GS# 362-066 West Lot Improvements (Paving and Renovations (Phase 1))

Woolfolk Building (Office of Capitol Facilities) (Department of Finance and Administration)

Addendum No. 2

SHEET **E001**

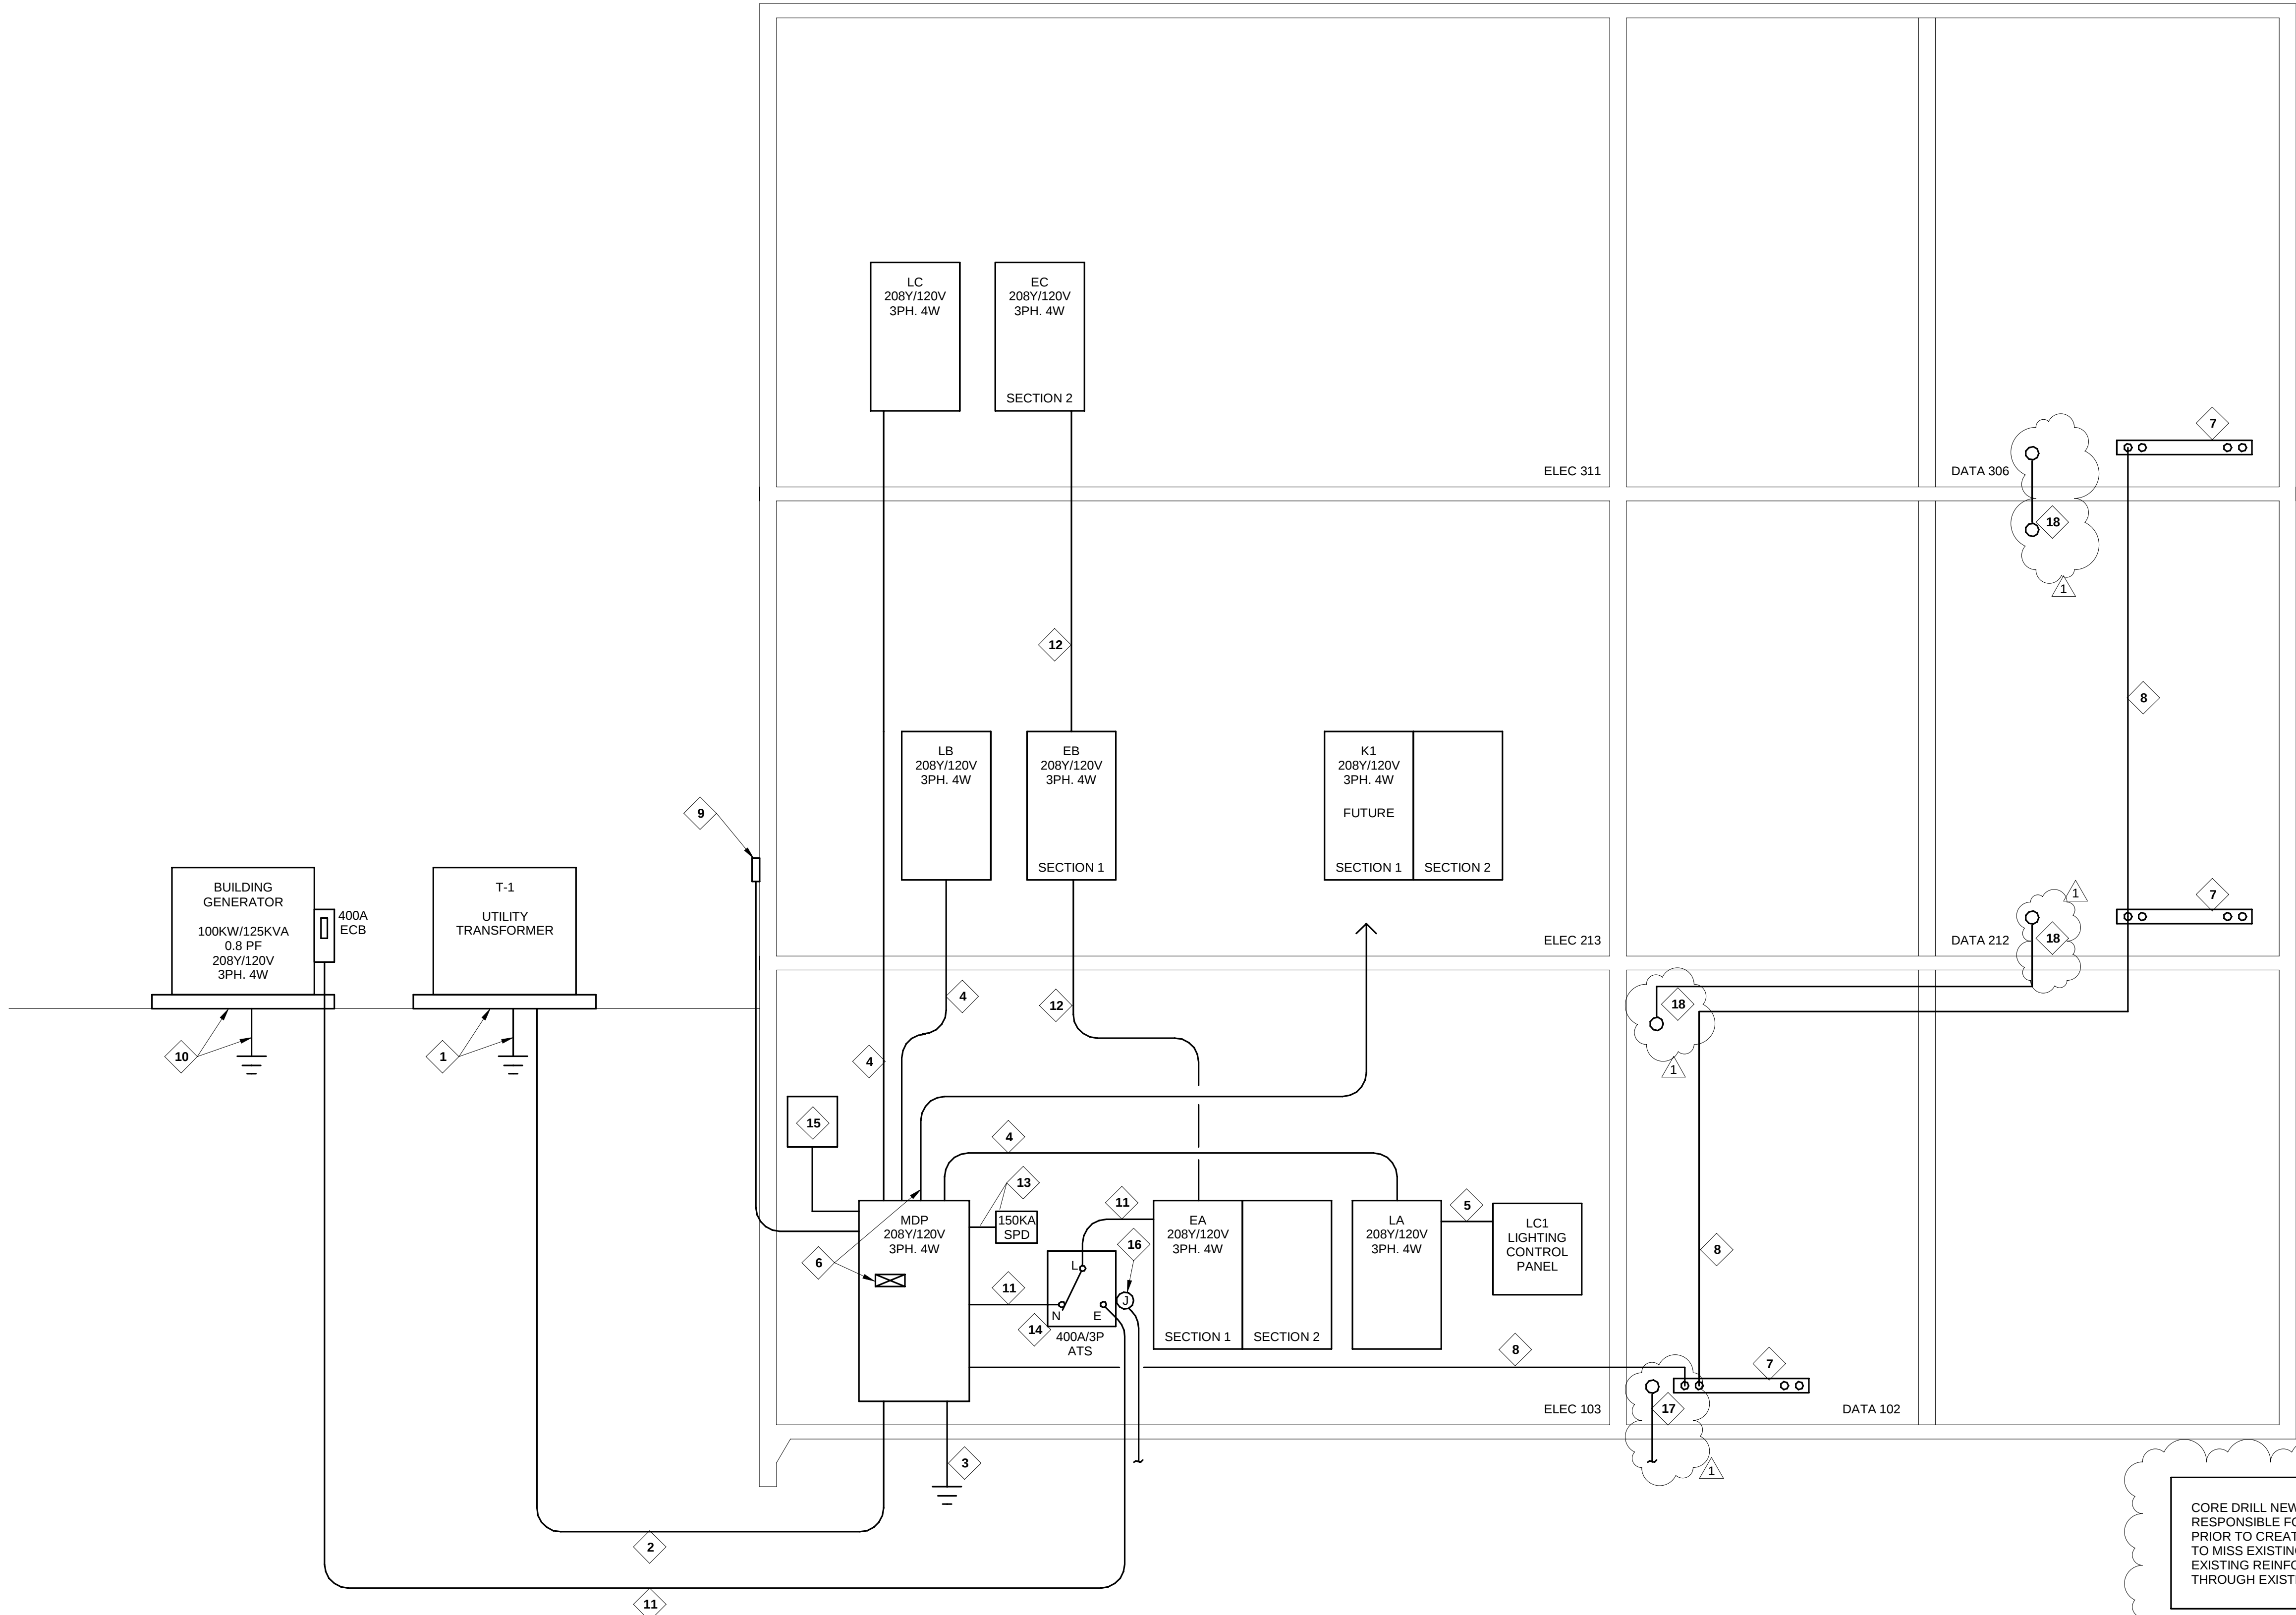
- g. A610 Finish Schedule:
 - i. Revise floor finish in Room 201 Lobby to LVT
 - ii. Revise floor finish in Room 202 Elevator Lobby to LVT
- h. E001 – Revised, see attached.

- i. ADDED SITE ACCESS CONTROLS TO SYSTEMS COORDINATION SCHEDULE
 - ii. REVISED LIGHT FIXTURE SCHEDULE
- i. ES101 – Revised, see attached.
 - i. REVISED SECONDARY ROUTING

1
ES102
COMMUNICATIONS AND
AUXILIARY POWER SITE PLAN
SCALE: 1"=20'

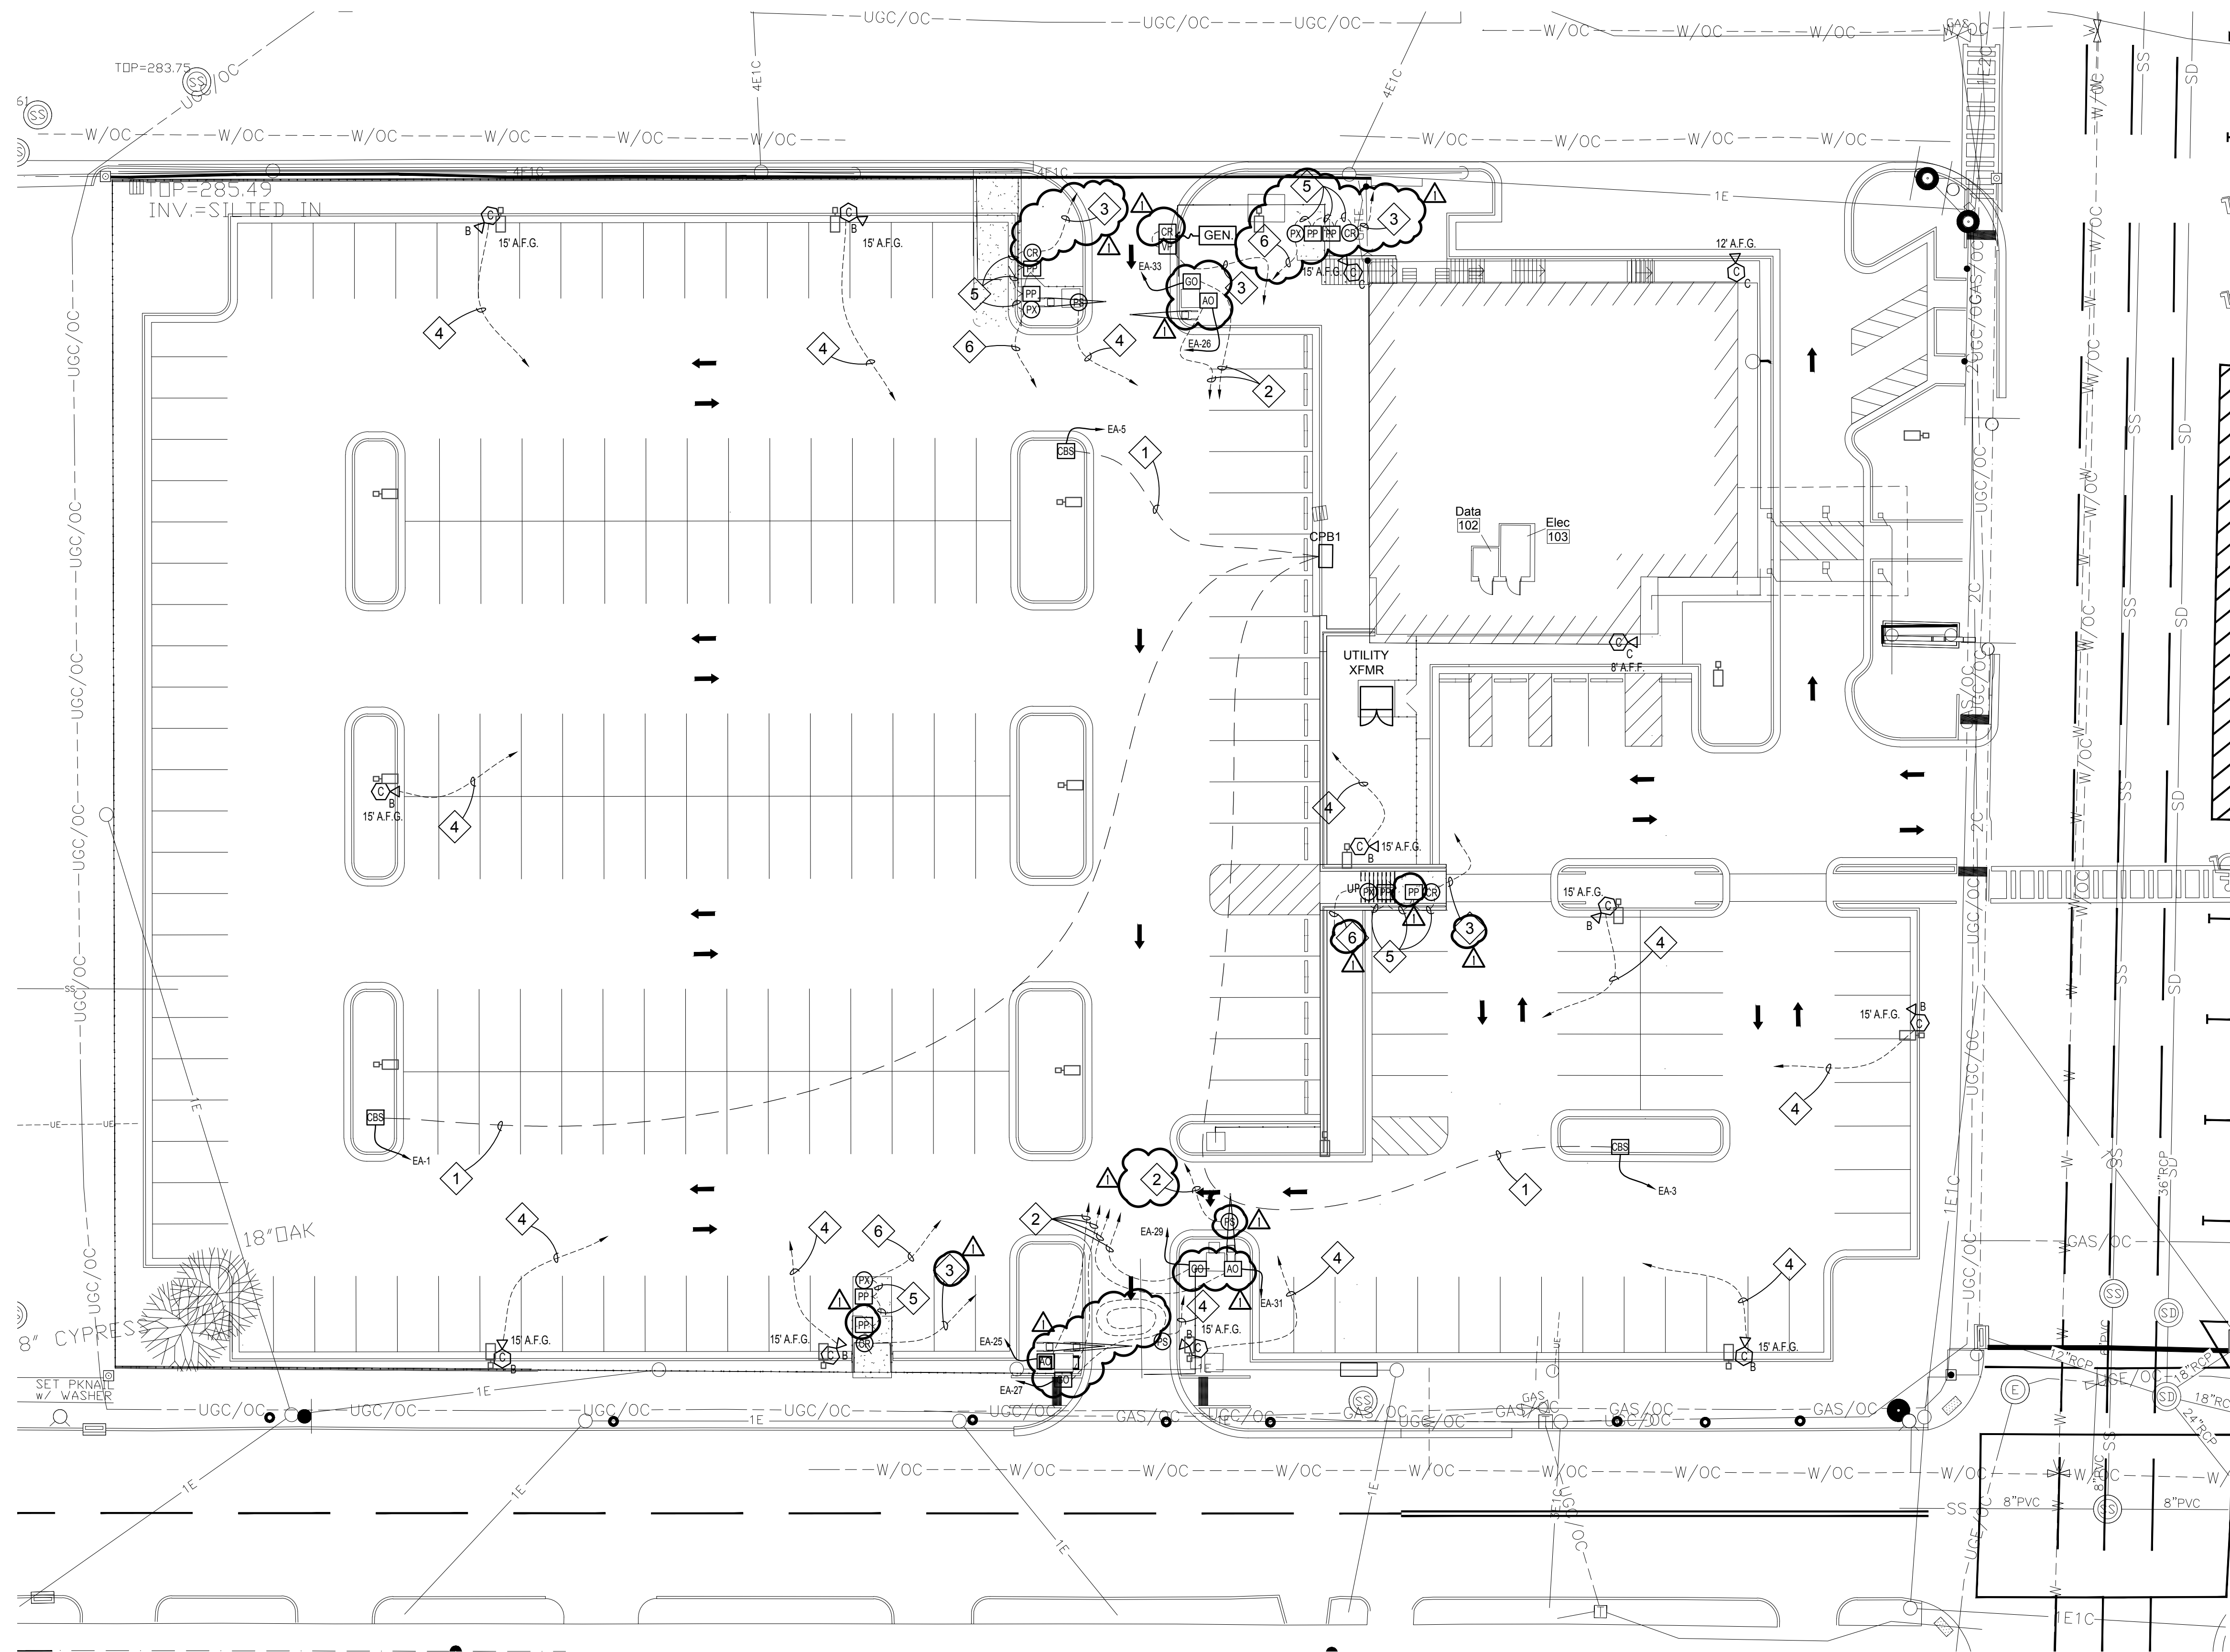
- j. ES102– Revised, see attached.
 - i. REVISED KEYNOTES 2,3,4, AND 6
 - ii. REVISED SITE ACCESS CONTROLS LOCATIONS AND INDICATIONS
- k. E501– Revised, see attached.
